18<sup>th</sup> DEFERRED May 2026  
Our reference: S\_1017.5288

**RE: DA 10.2025.156.1 (PAN-532102) 5 Penny Lane, Byron Bay – Request for Additional Information**

We refer to Councils recent request for additional information (RFI) dated 20 April 2026 and provide the following responses to the stormwater related items, particularly 1 and 4 of the RFI:

| Title:                                                                                             | STG 5 STORMWATER & FINISHED GROUND FLOOR LEVELS PLAN |

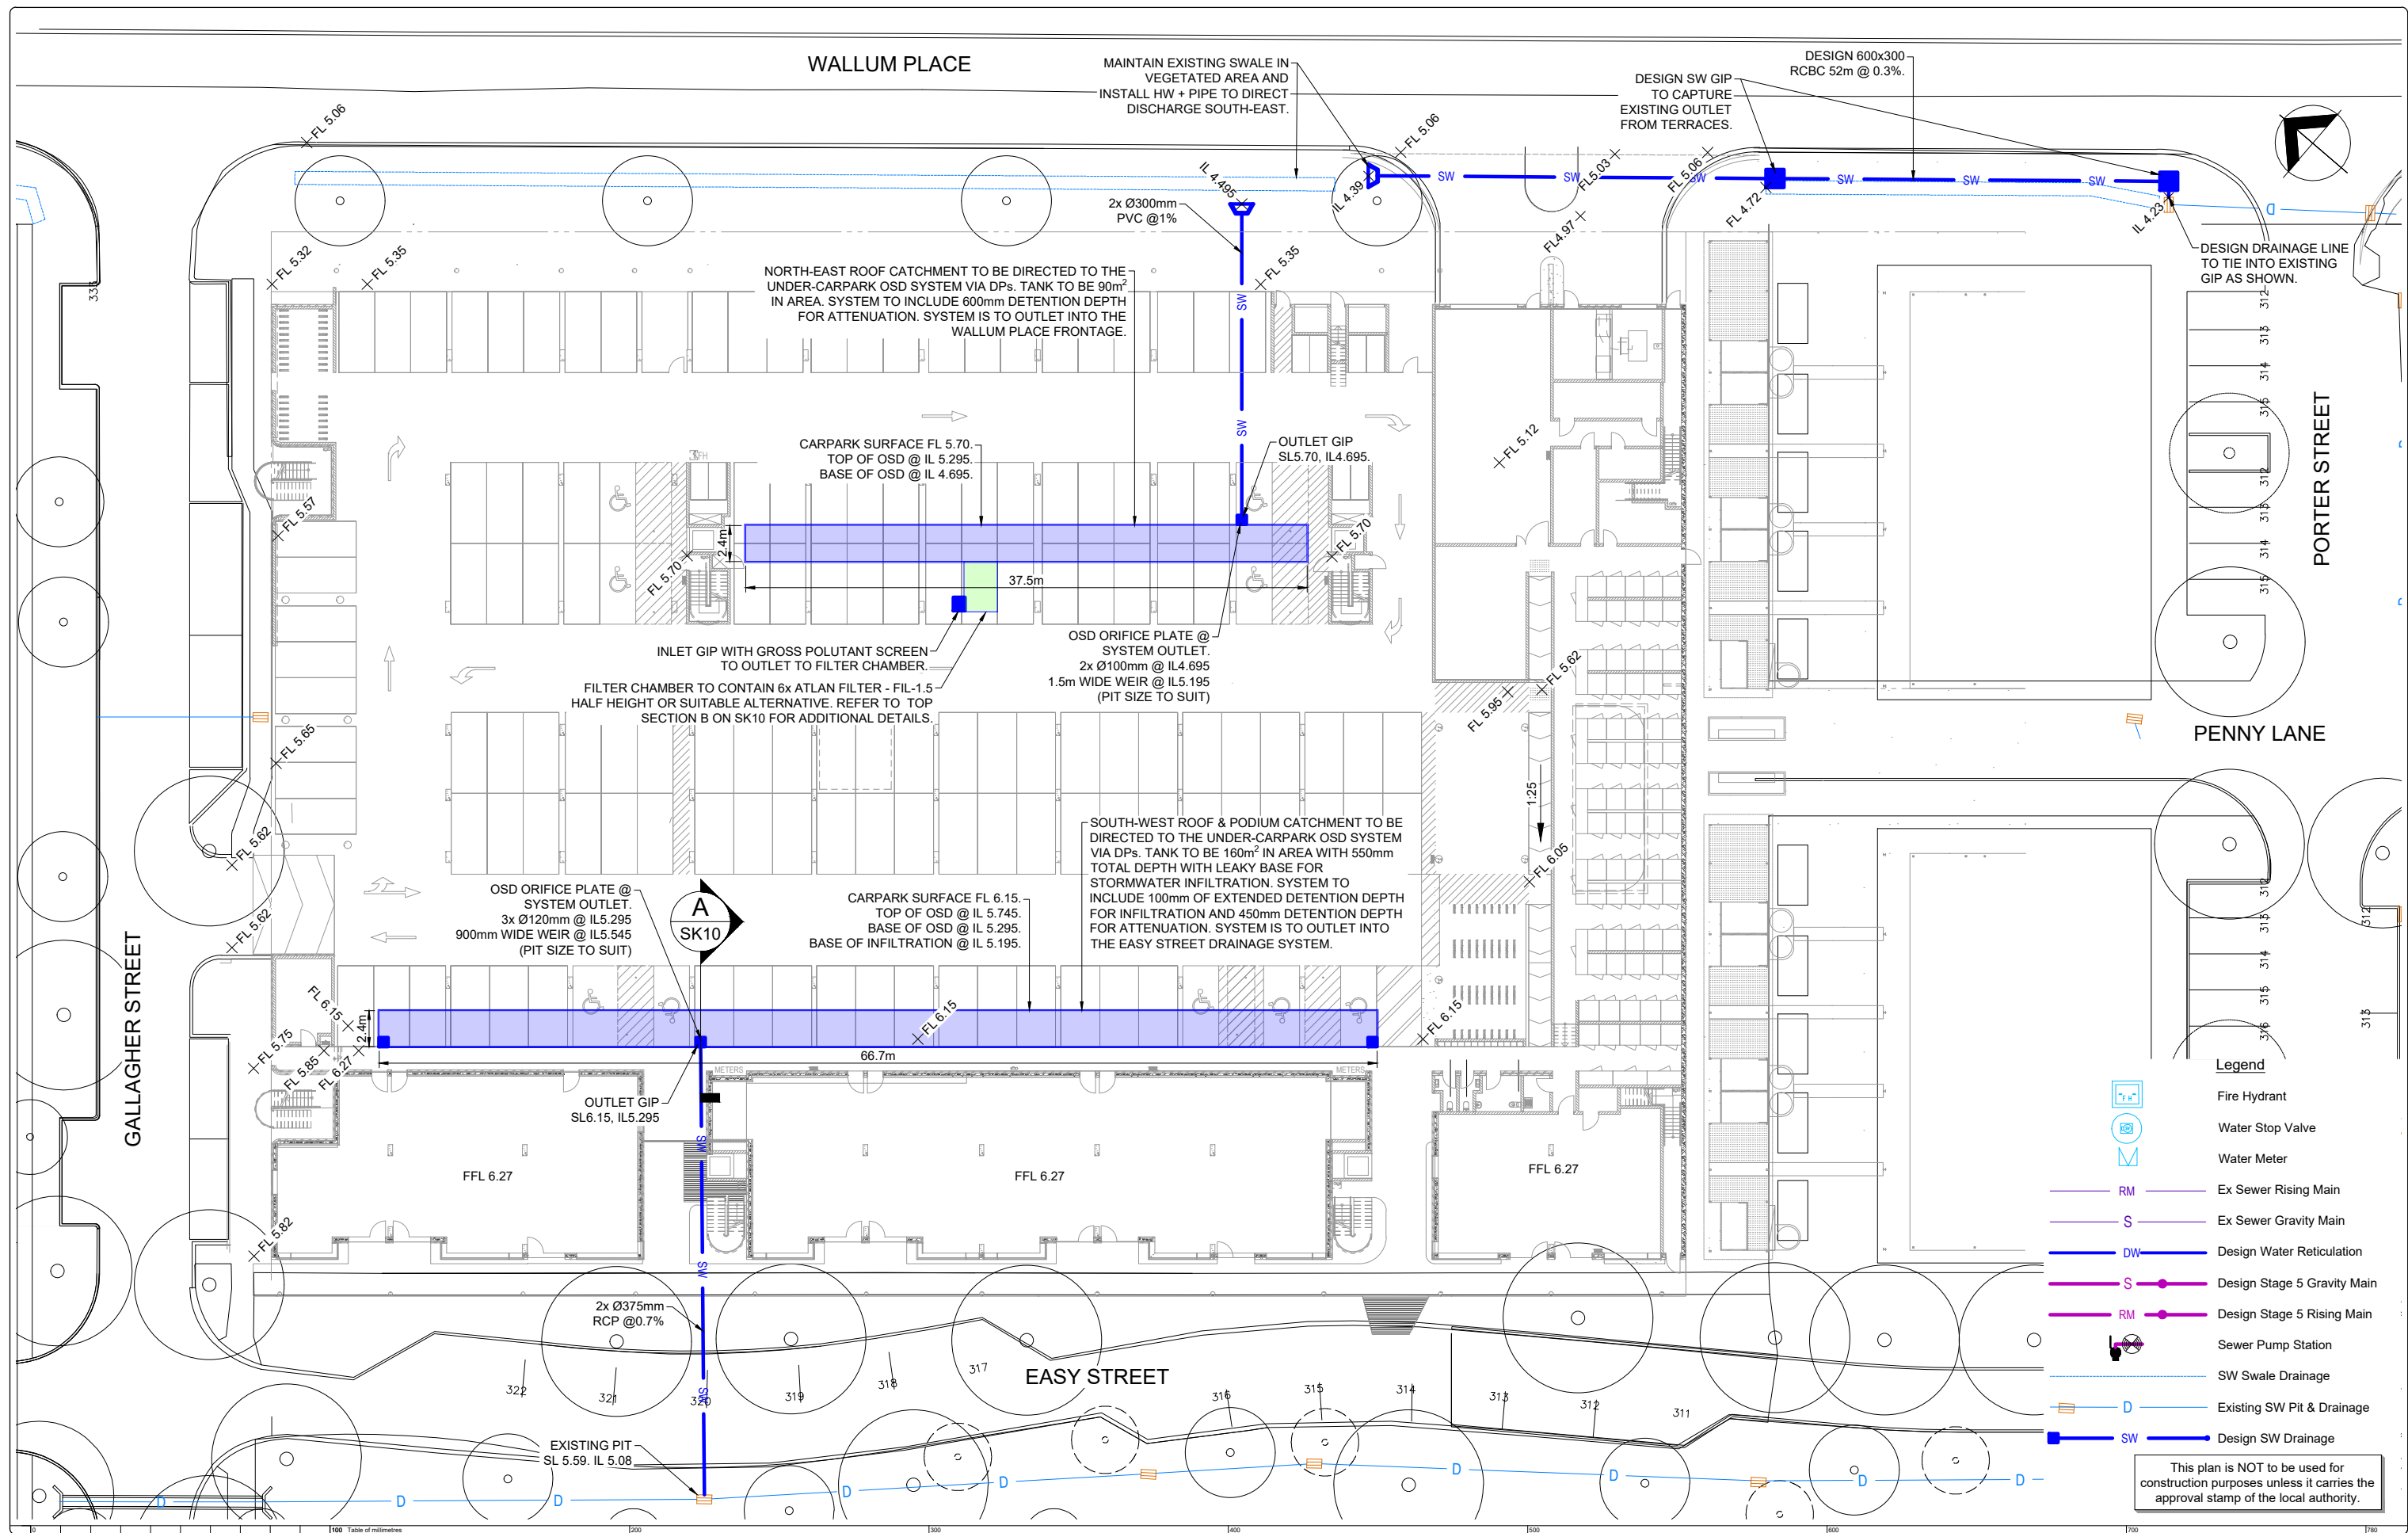
- Provide information demonstrating that the proposed OSD systems can achieve a vertical separation distance of at least 1m from the highest seasonal groundwater level, and that the OSD will not suffer from compromised system performance due to interaction with ground water.
- Provide information explaining how the OSD systems will be accessed for maintenance and / or replacement of filter media in the future.

***Amended design of the North OSD system to provide a volume of 56m<sup>3</sup> or greater and a 1 x 100mm orifice outlet.***

The OSD tank is documented as having a volume of 54m<sup>3</sup> given a base of RL 4.695 and top of RL 5.295. The surface level in the carpark is currently nominated at RL 5.7 We can simply increase the top of the tank from 5.295 to 5.4 to achieve the volume leaving 300mm for the carpark slab over. The modelling for which Council has based the 56m<sup>3</sup> from appears to be APP's DRAINS model. This model includes 2 x 100mm outlets as shown in the amended report issued before the NRPP meeting, we propose that this arrangement is provided in the final design. Drawing SK07 has been updated to reflect the change in the Volume.

Post discussions with Council regarding this, we have provided an alternative gross pollutant screen and Atlan filter system for lower Northern System. The details of this are provided on drawing SK10. Music modelling input and results are also provided electronically.

**D SECTION**  
SK07 ATLAN FILTER CHAMBER (TYPICAL)  
SCALE 1:20 AT A1

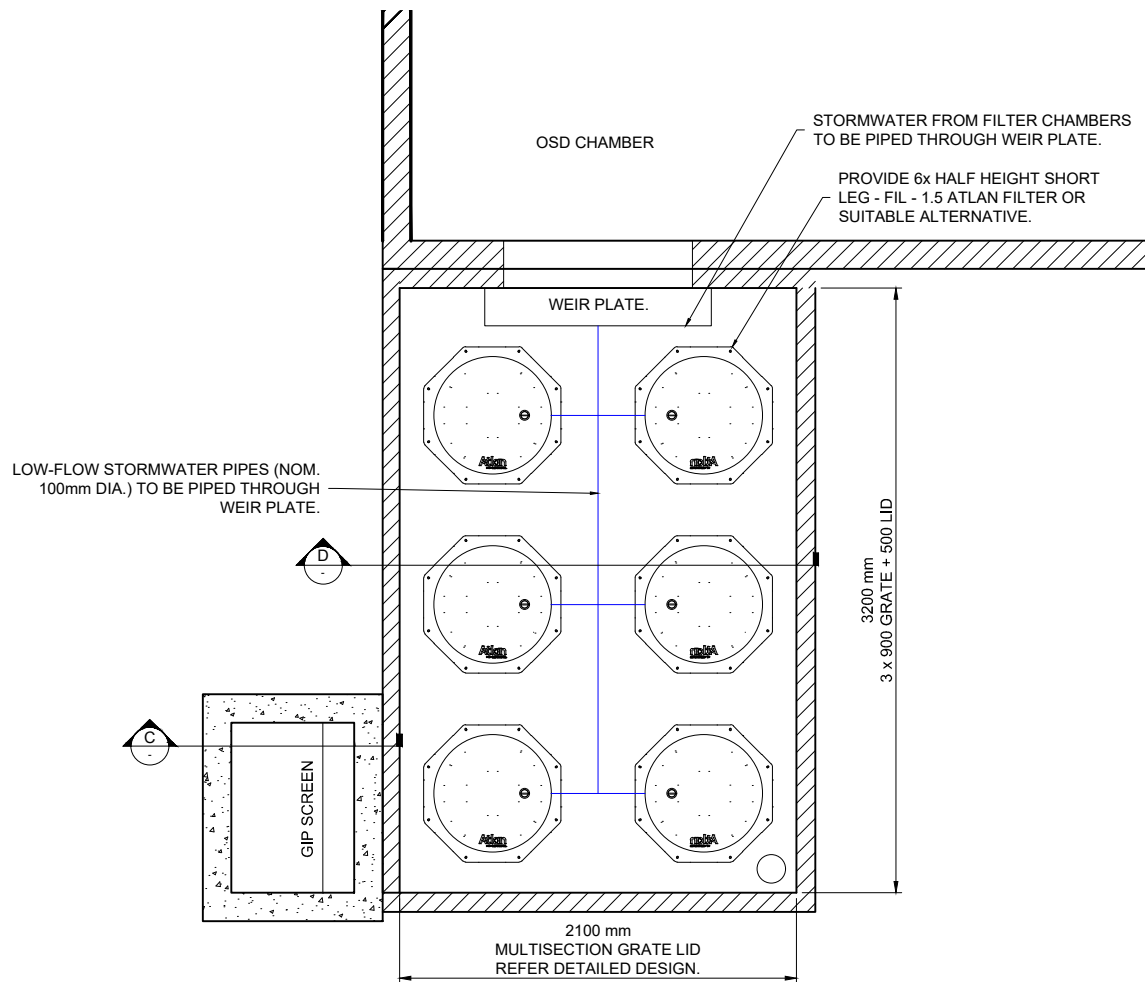
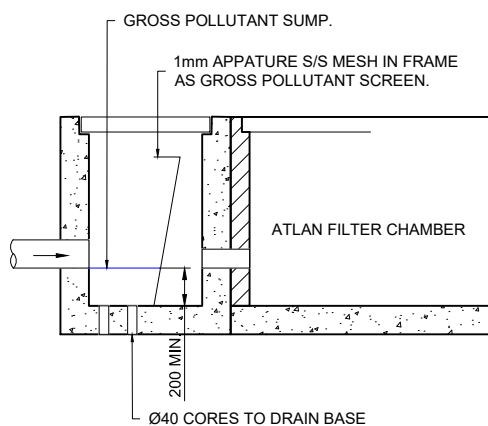
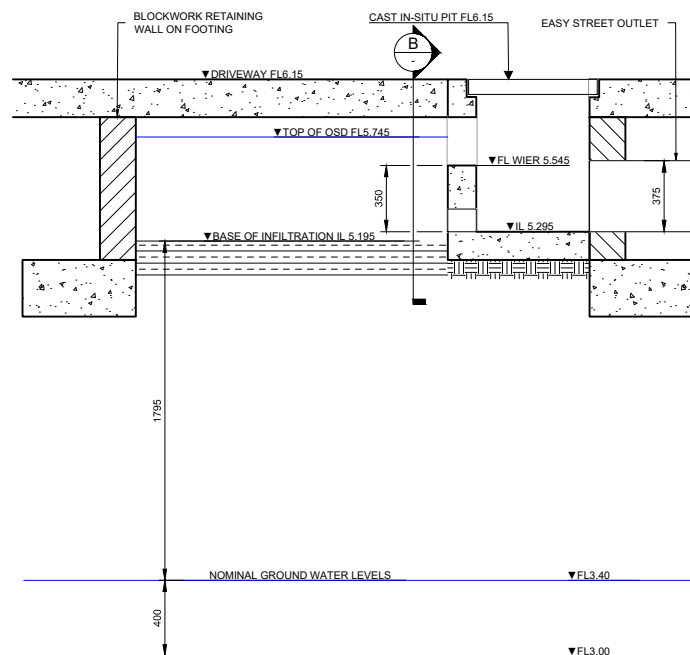
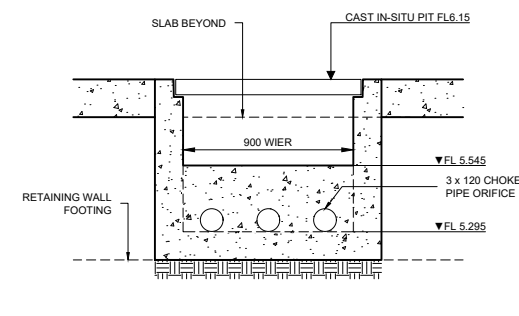
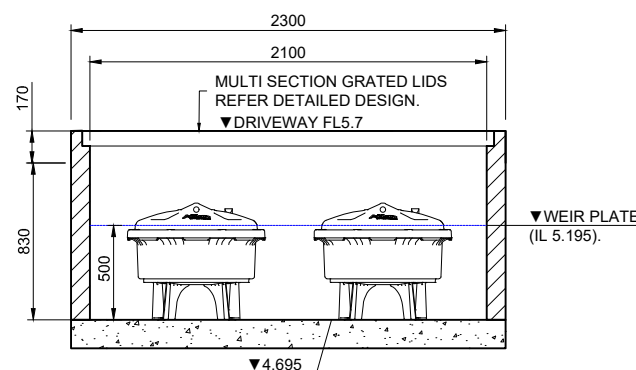
***Provide information demonstrating that the proposed OSD systems can achieve a vertical separation distance of at least 1m from the highest seasonal groundwater level, and that the OSD will not suffer from compromised system performance due to interaction with ground water.***

FLOOR PLANS - 0. GROUND  
1:110

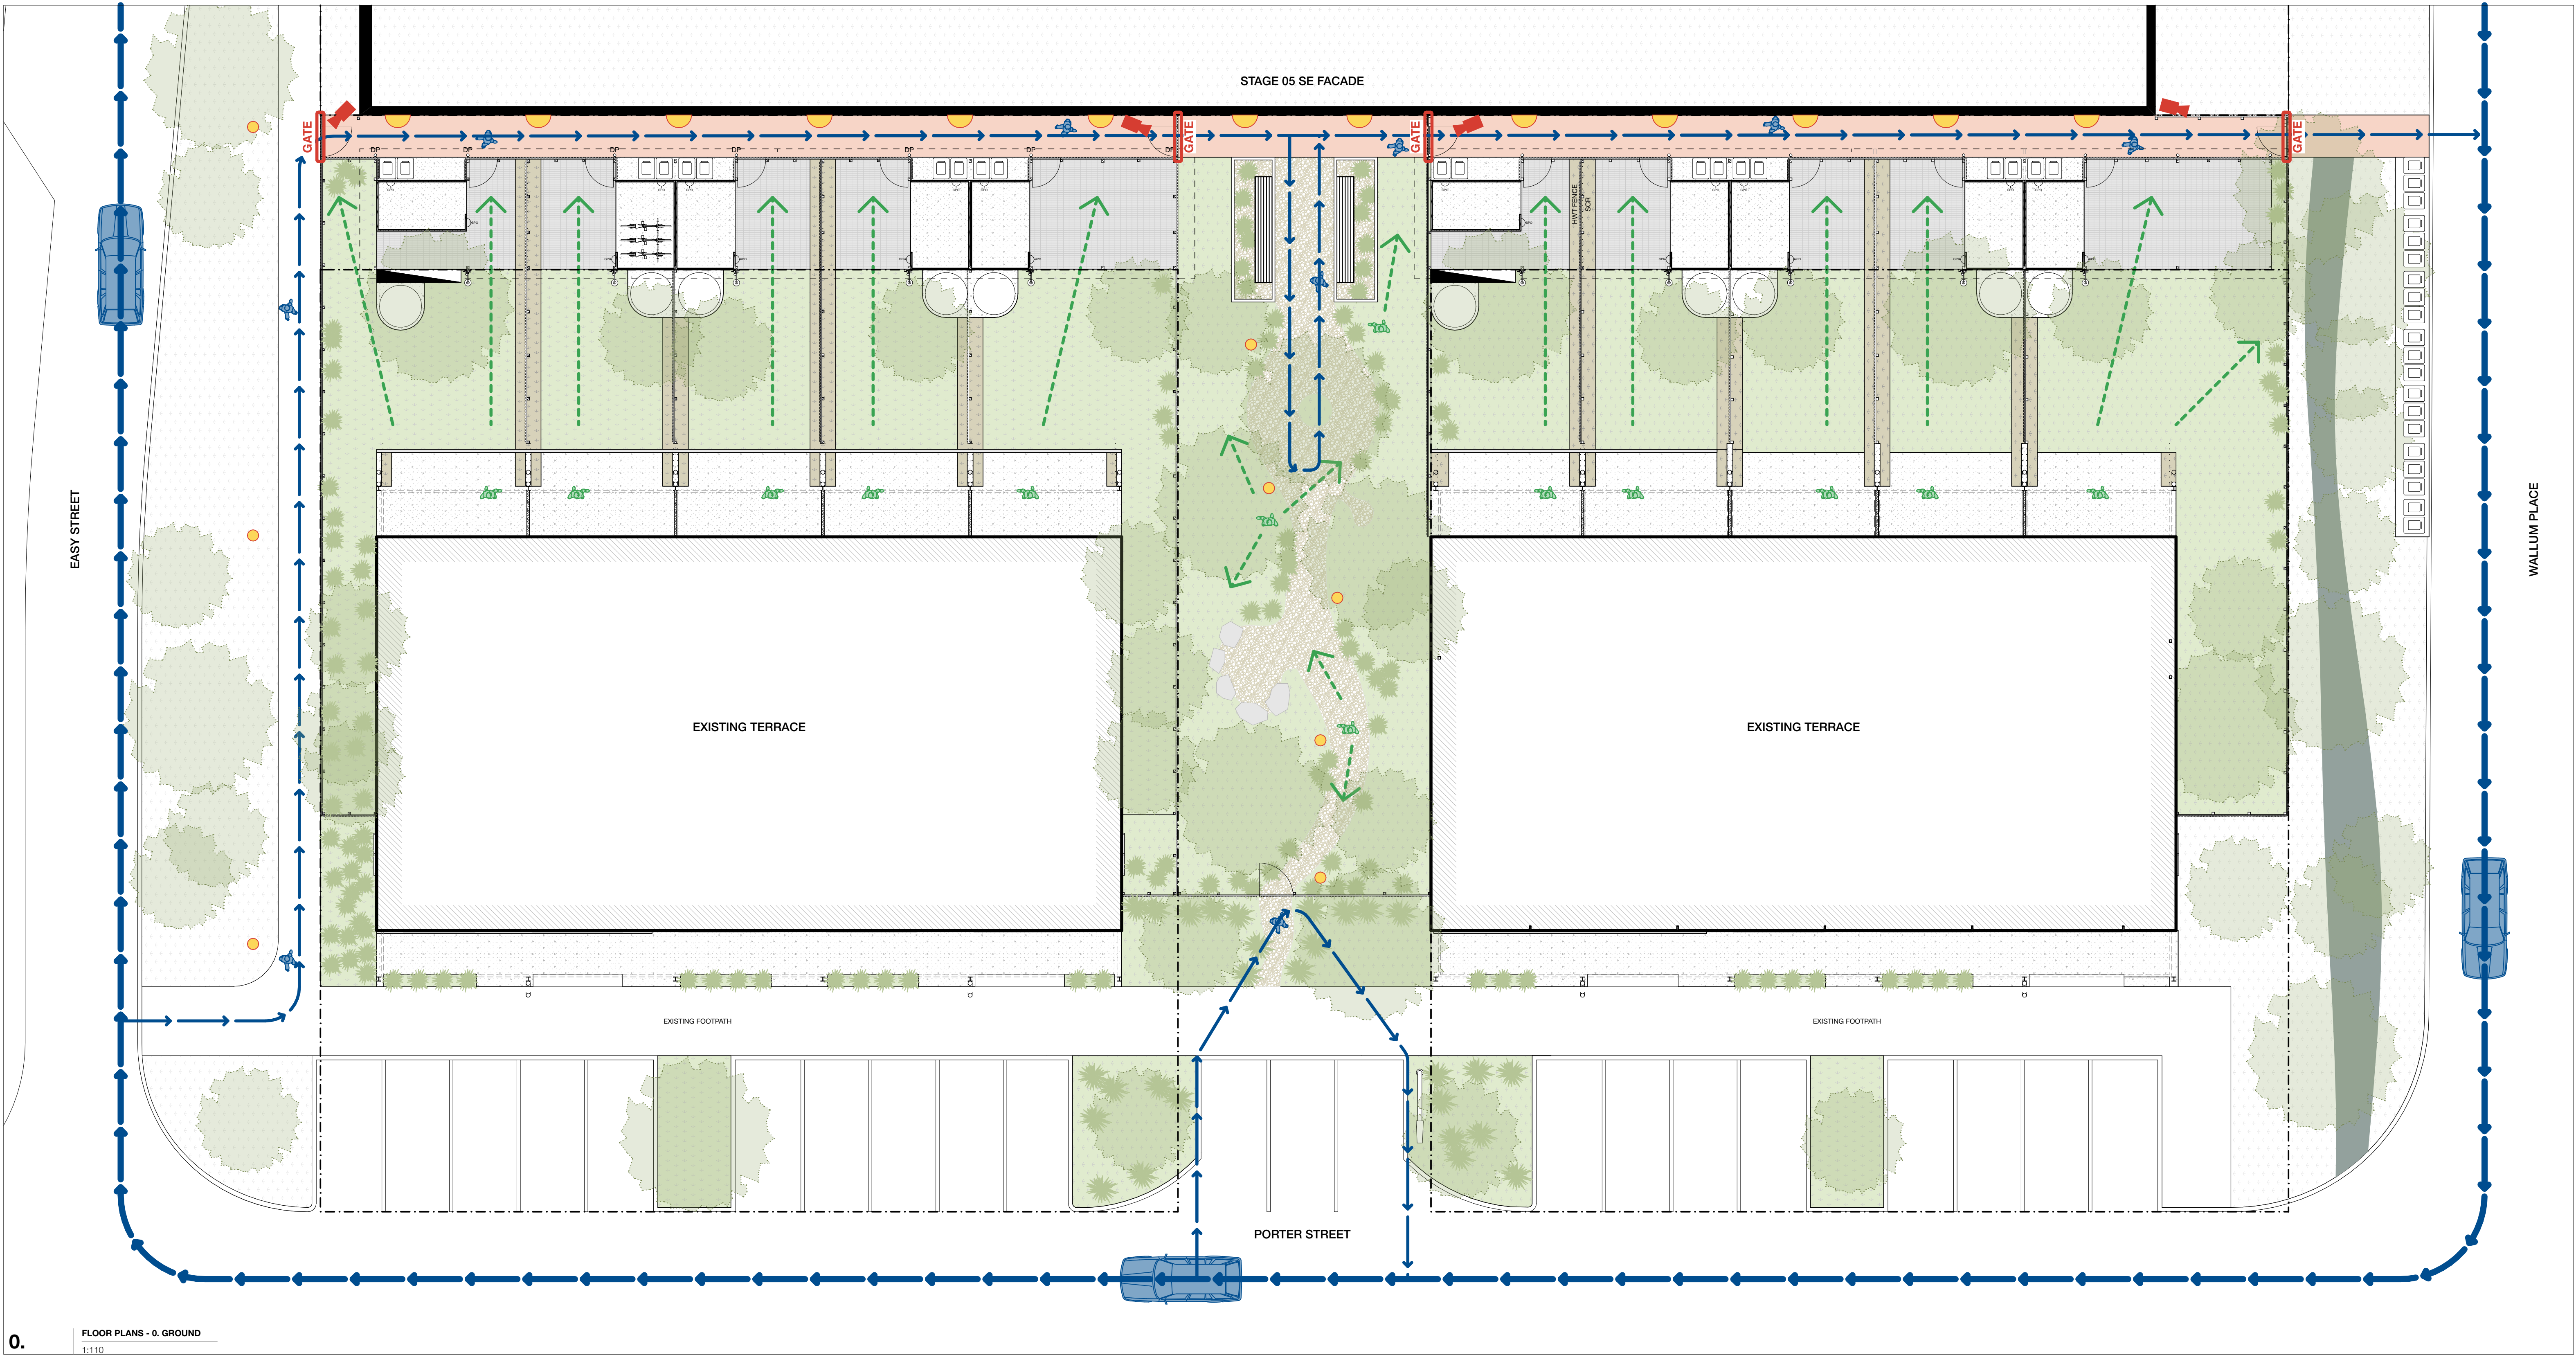
- Public safety and CPTED resolution of the ground level space between the Porter Street terraces and the southeast building façade.

The applicant has reviewed this matter against the relevant CPTED framework and proposes a coordinated package of refinements specific to the south-east walkway. The package builds on what is already shown on DA986 Rev 05 (Ground Floor Compliance Plan — CPTED, MANA, 11 April 2025) and provides additional detail in the area flagged. A CPTED drawing focused on this area accompanies this letter (**Appendix A**).

- Four mandatory 1.8m hardwood timber gates with anti-climb top detail (one at the Easy Street end, one at each side of the pocket-park crossing, and one at the Wallum Place end), replacing the 1.2m '*optional*' gates currently shown on the architectural set;
- Entry controlled by swipe-card or keyed access for residents and authorised tenants only, integrated with the existing Habitat-wide access-control system for shared facilities (pool, bin enclosures, amenity rooms, and other shared facilities); and
- Free egress from inside the walkway at all times without key, swipe-card, or other interlock.

3.5 Territorial Reinforcement: Discreet signage at each of the four gates will read "*Residents and Service Access Only*" (or equivalent). The walkway itself will be finished in brushed (broom-finish) concrete — distinct from the washed concrete on the new public footpath along Easy Street where the walkway gates open. The change in surface marks the transition between public and managed space. The brushed finish also suits the regular movement of wheelie bins along the run. The 400-millimetre planted strip currently shown along the building wall will be removed, delivering the full 1.5-metre walkway width and clear sightlines along the run.
